## Product Change Notification / RMES-16SJK0622

CCB 4550 and 4550.001 Initial Notice: Qualification of STAR as an additional assembly site for selected Micrel products available in 4L VDFN (3.2x 2.5 x 0.9 mm) and (2.0 x2.5 x0.9 mm) packages.

# LEAD FRAME COMPARISON

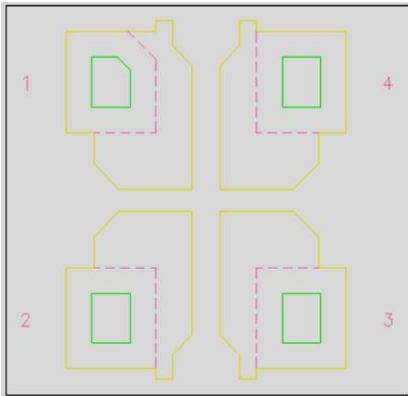
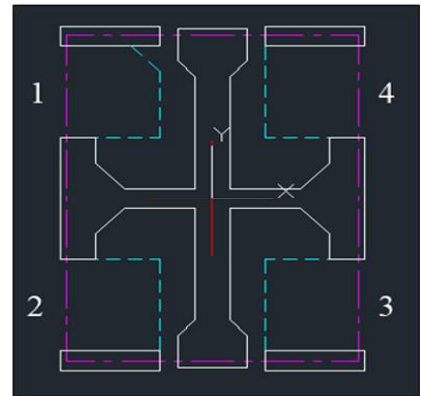
<b>Leadframe Material</b>	A194
<b>Lead Lock (Locking Hole)</b>	No
<b>Lead Plating</b>	NiPdAu

<b>Leadframe Material</b>	A194
<b>Lead Lock (Locking Hole)</b>	No
<b>Lead Plating</b>	NiPdAu
